Land North of Bryn Lane, Wrexham Industrial Estate

WCBC Highways Consultation Response

Job No 329525

Figure 5.1 : Proposed Substation Access

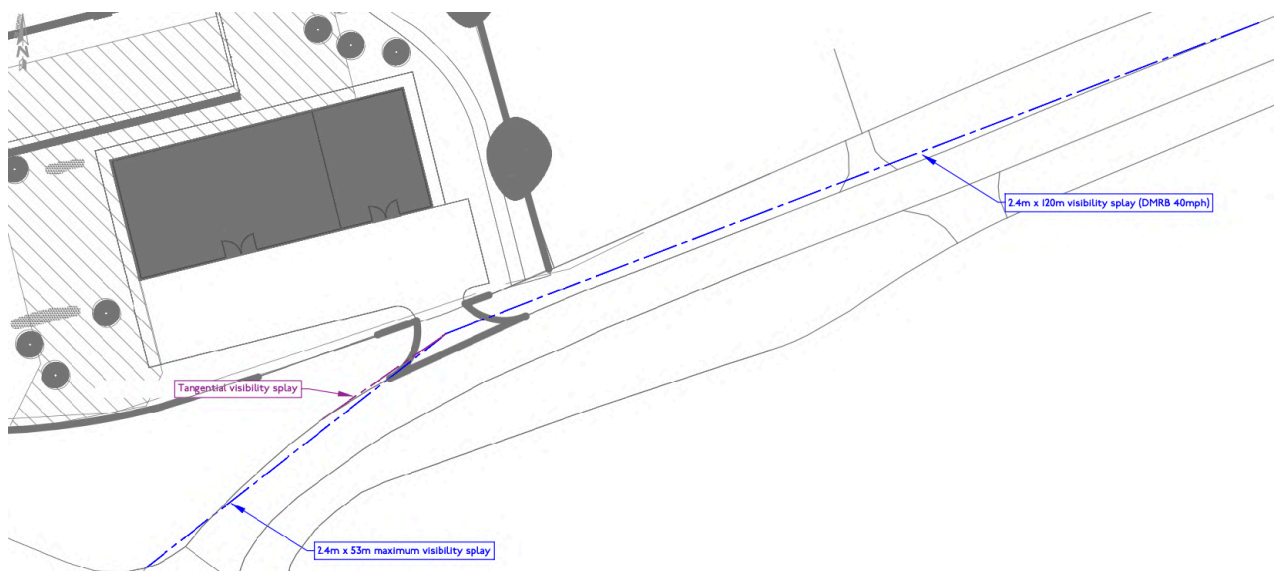
Despite previous requests, swept-paths and visibility splays have not been provided for the substation on Ridley Wood Road. Such information is required where any new permanent access onto the highway is proposed. Swept-paths are needed to demonstrate suitable vehicles can enter and egress the sub-station area in a forward gear and will not need to reverse into or from the carriageway.

- 5.1.1 The proposed substation access, with achievable visibility splays along Ridley Wood Road, is shown in [Figure 5.1](#), and in **Drawing No. J32-9525-PS-020** attached in [Appendix D](#).

- 5.1.2 In accordance with the signed speed limit of 40mph, a 2.4m x 120m visibility splay is achievable to the east. The maximum visibility splay of 2.4m x 53m to the west is shown to the junction with Bryn Lane.
- 5.1.3 Swept path analysis has been undertaken for a 10m Rigid vehicle, which demonstrates the vehicle can enter and exit the site in a forward gear. This is shown in [Figure 5.2](#), and in **Drawing No. J32-9525-PS-020** attached in [Appendix D](#).

Swept Patch Analysis - B2 Masterplan
Units 14 & 15

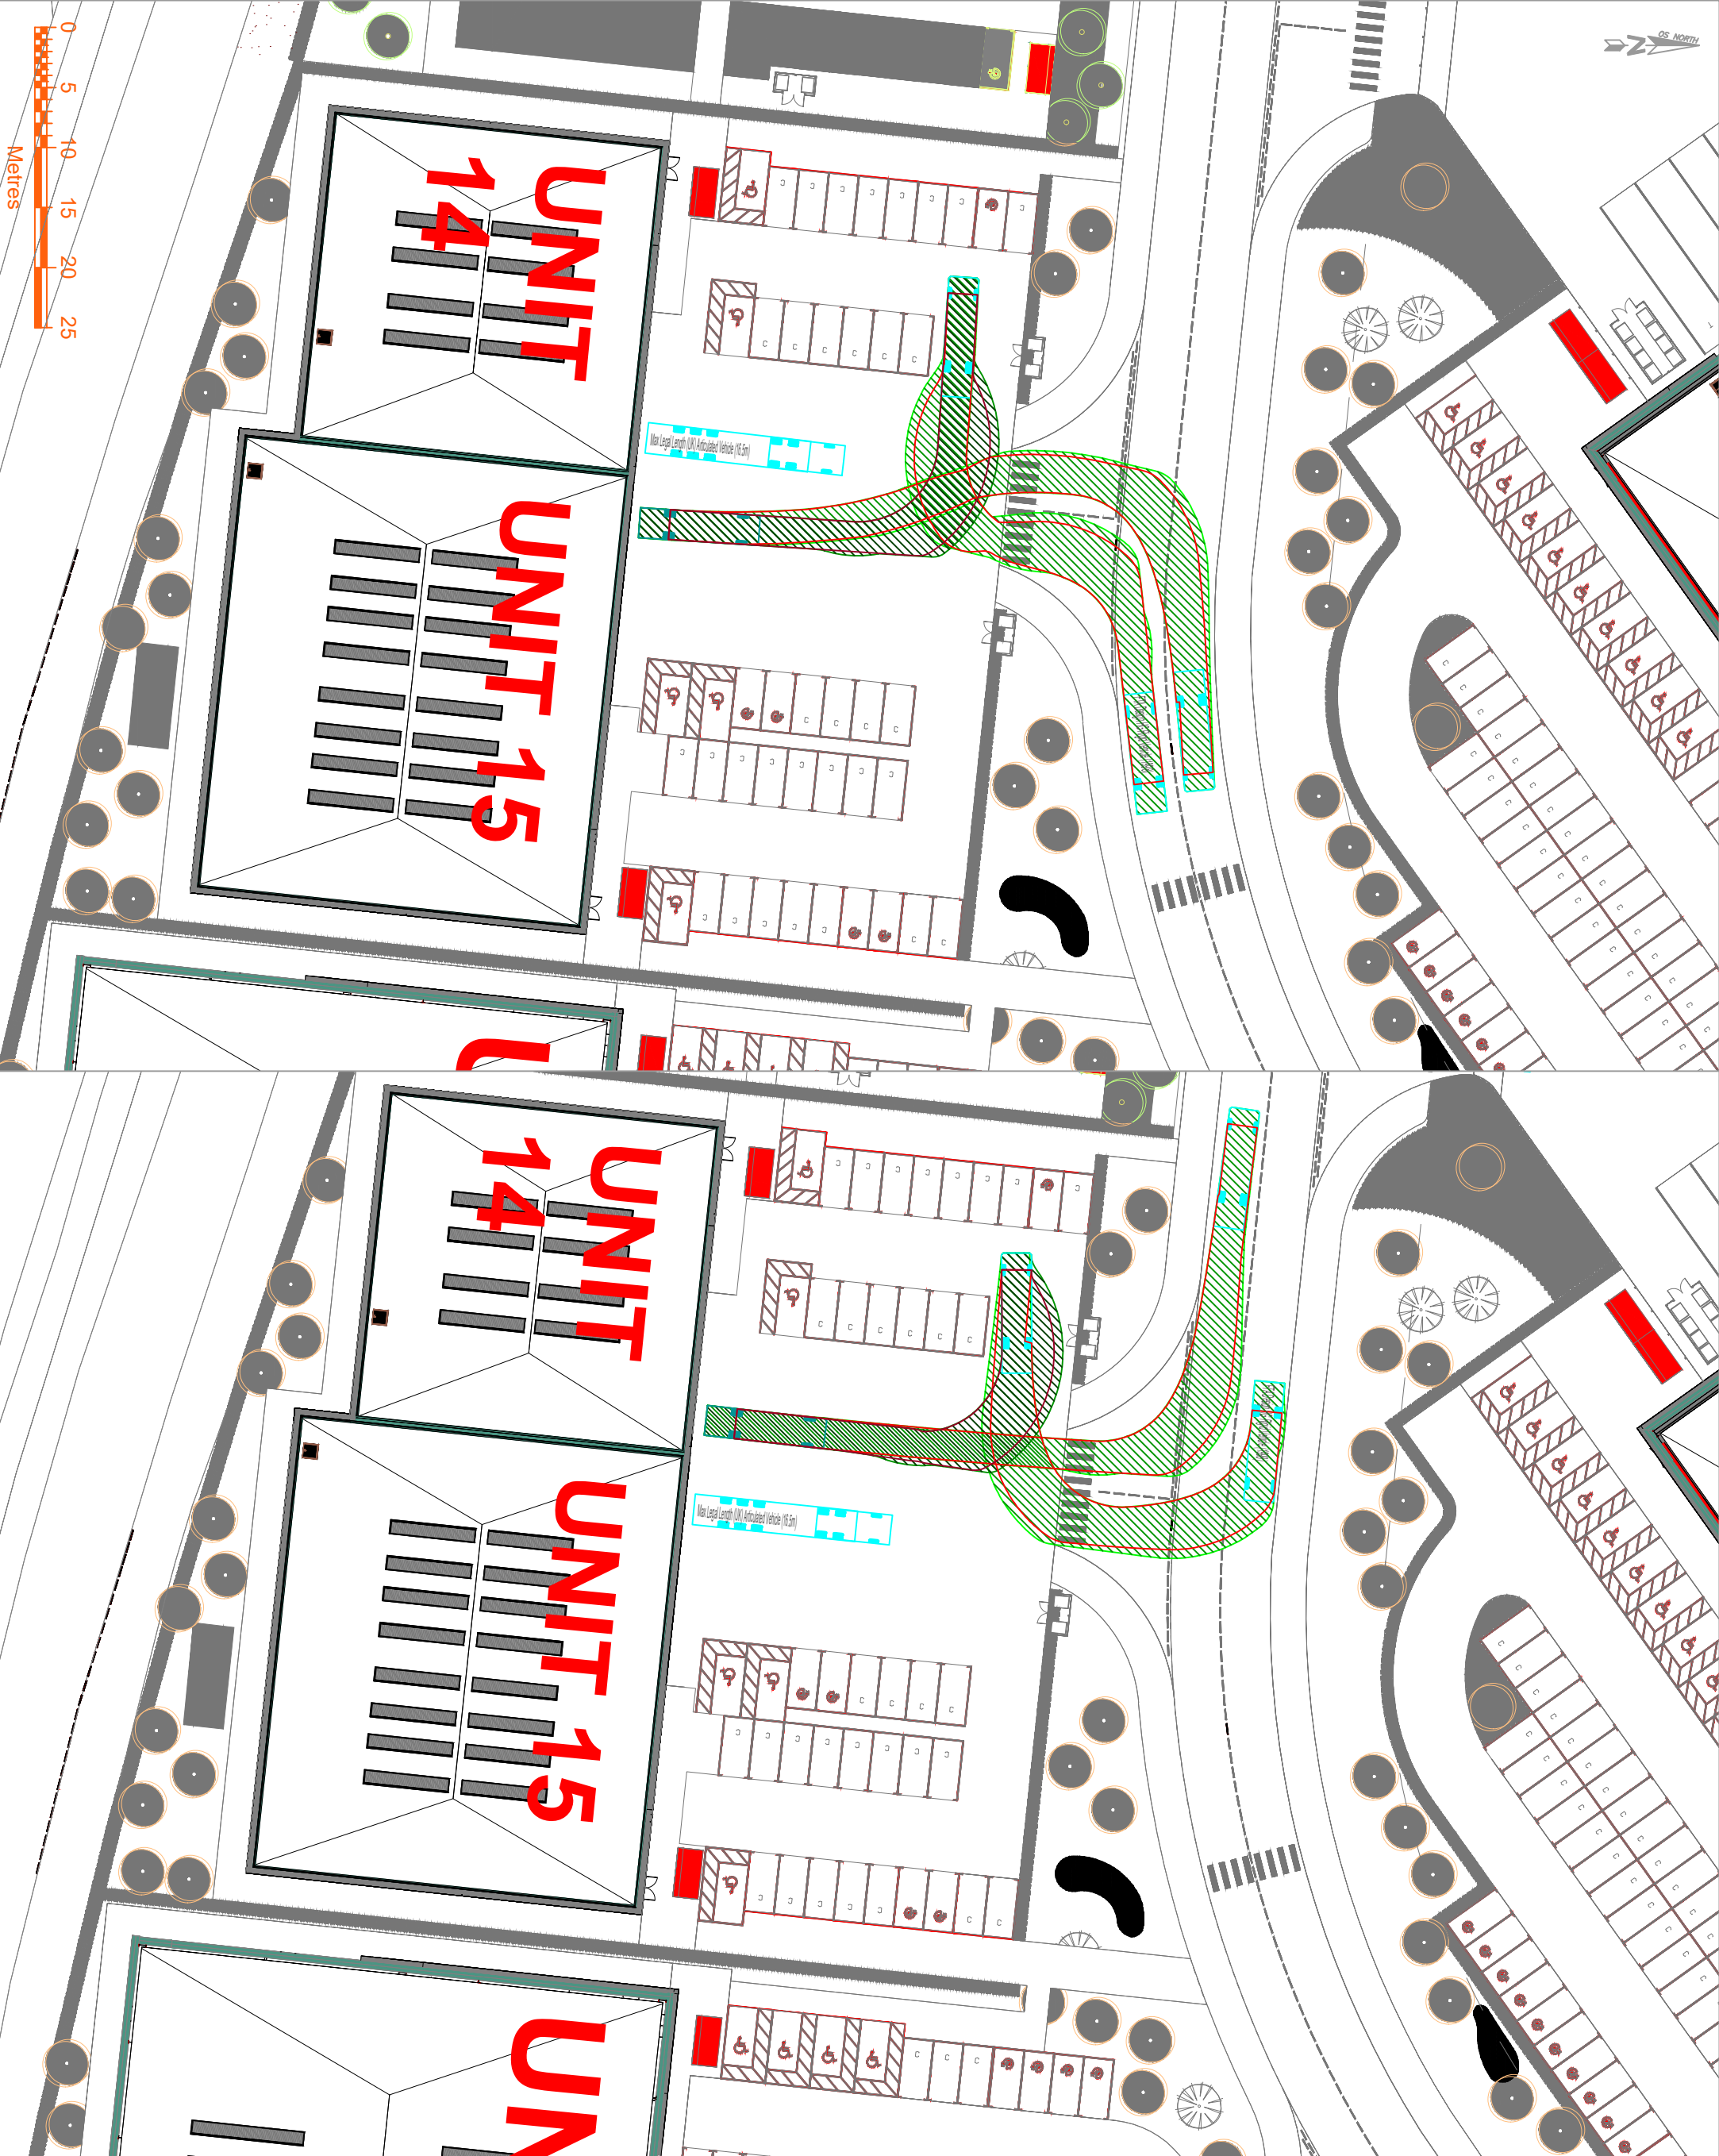
Unit 14 and 15 B2 Layout - These two units share an access and manoeuvring space. The LHA have concerns over shared manoeuvring space unless there is a control mechanism to ensure this space is safeguarded and maintained for this purpose alone. The swept-paths should assume a HGV parked at the loading bay of the adjacent unit to demonstrate the movements are still practical if a HGV is loading in this adjacent bay.

4.2.1 As demonstrated by the swept path analysis attached in [Appendix C](#), the shared service yard serving Units 14 and 15 can accommodate simultaneous servicing movements by 10m rigid HGVs and a 10m rigid with a 16.5m articulated HGV, with vehicles able to access and egress both units independently.

- 4.2.2 For larger vehicles, the swept path analysis demonstrates that a 16.5m articulated HGV can access and egress the LAD serving either Unit 14 or Unit 15 in a forward gear when the LAD serving the adjacent unit is occupied by a 10m rigid HGV. However, due to the parking requirements for the B2 use reducing the available space within the service yard, manoeuvring by a 16.5m articulated HGV would be constrained where a 16.5m articulated HGV is already parked at the adjacent LAD.

- 4.2.6 Given the very low frequency of HGV arrivals, the likelihood of a 16.5m articulated HGV arriving at one unit while a 16.5m articulated HGV is already occupying the LAD at the adjacent unit is considered to be low. Simultaneous servicing of the two units by a 16.5m HGV would therefore represent an infrequent occurrence.

- 4.2.7 While the swept path analysis identifies a constraint where a 16.5m articulated HGV seeks to manoeuvre while the adjacent LAD is occupied by a 16.5m HGV, the swept path analysis demonstrates that if the adjacent unit is occupied by a 10m rigid HGV, then independent access is achievable. In addition, the forecast HGV demand indicates that this event would be unlikely to occur on a typical day. The proposed arrangement is therefore considered appropriate to accommodate the anticipated servicing requirements of Units 14 and 15 for a B2 land use.

UNIT 6

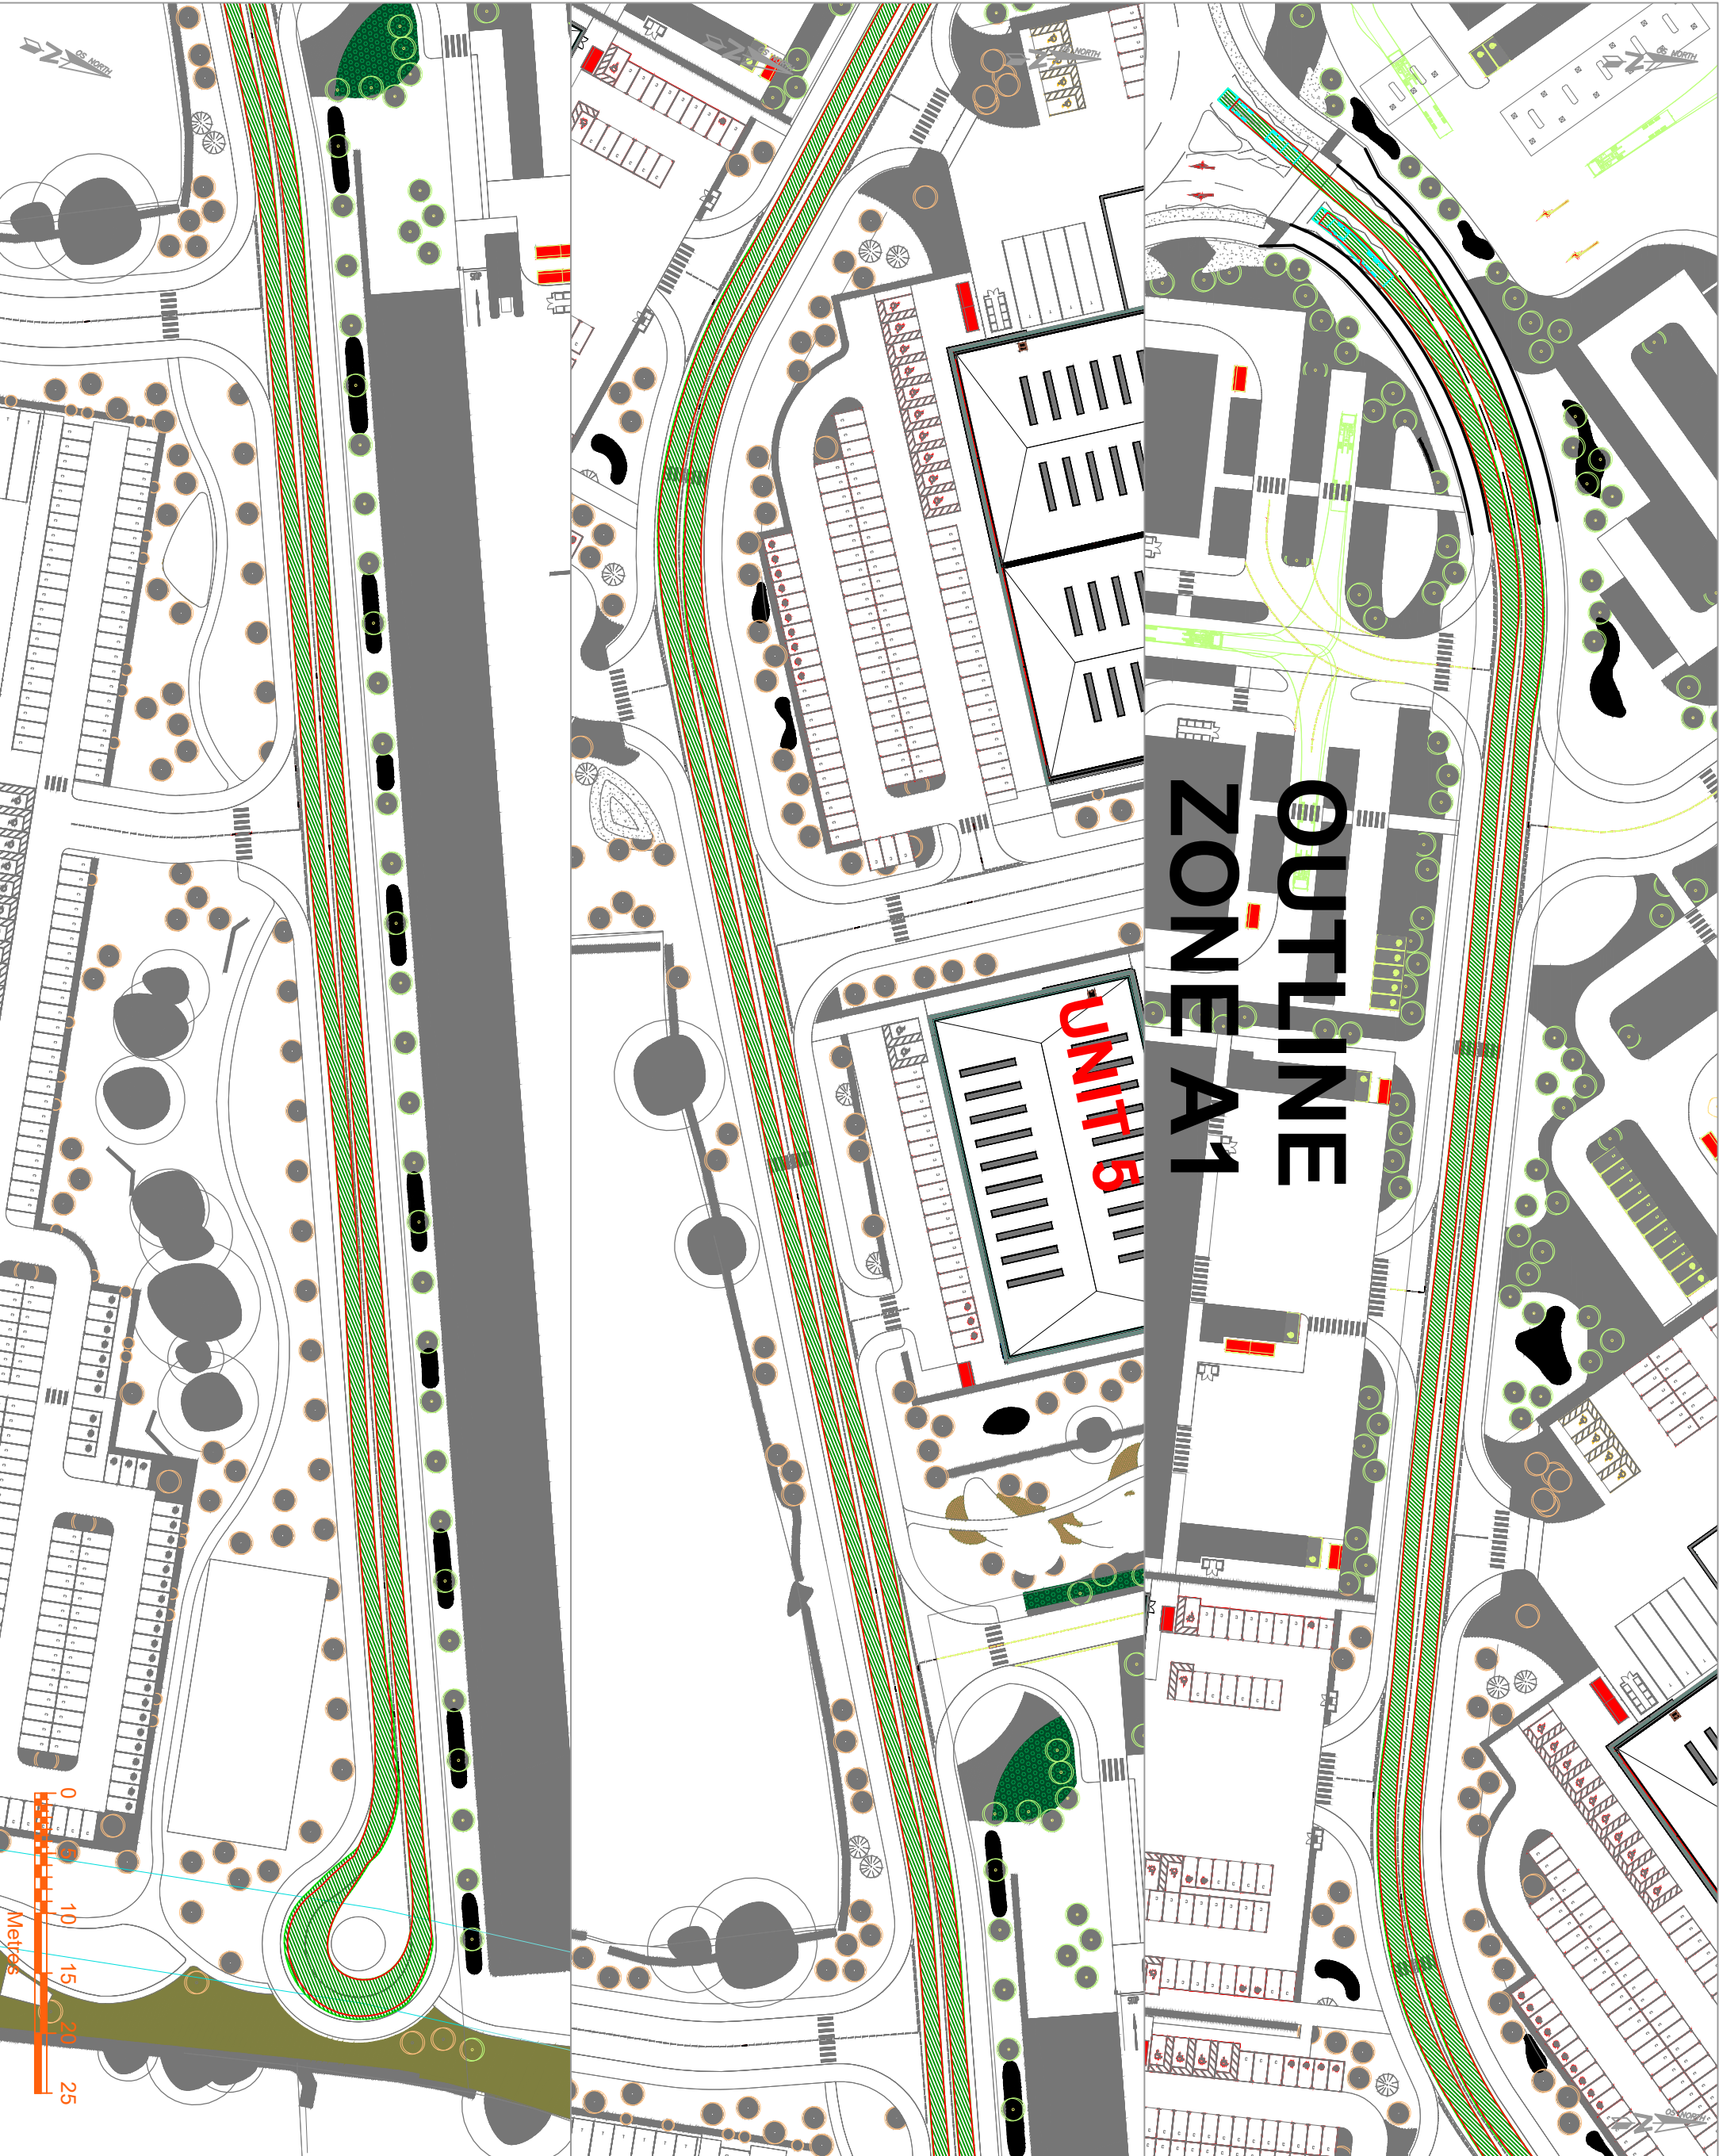
Unit 6 B2 Layout – as noted above, the most onerously positioned HGV bays have not been assessed.
